DCP/NRC1487
Project 711

SUBJECT: Westinghouse Responses to NRC Requests for Additional Information

**Westinghouse Non-Proprietary Responses
to Requests for Additional Information
Regarding the AP1000 Pre-Certification Review**

AP1000 PRE-CERTIFICATION REVIEW

Figure P59-1: Upper Head Level – 1-inch Cold Leg Break

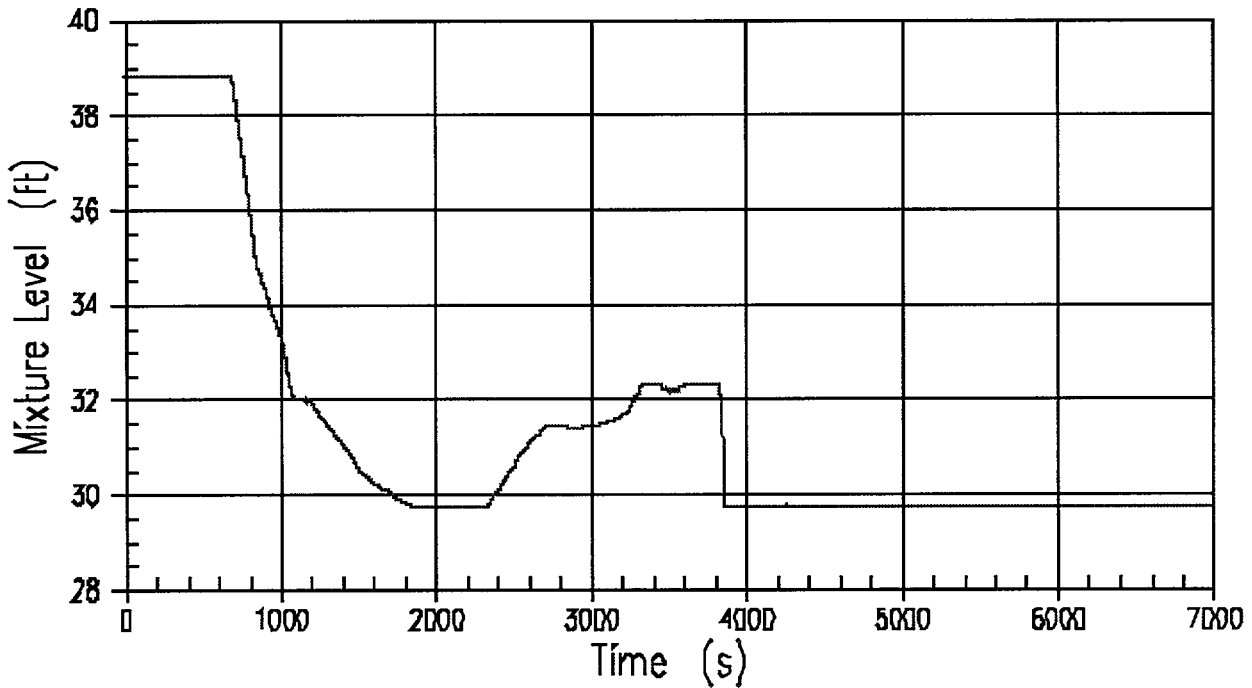
For the one-inch cold leg break, provide figures showing predictions of water levels in the vessel upper head and upper plenum, the accumulators, the CMTs, and the pressurizer. Also, provide a figure showing the core exit flow quality, the steam flow at the core exit, the core inlet flow, the core inlet subcooling and the pressurizer pressure.

Attached please find the requested plots. Note that these plots were generated with our preliminary NOTRUMP model used for the scoping analyses provided in WCAP-15612.
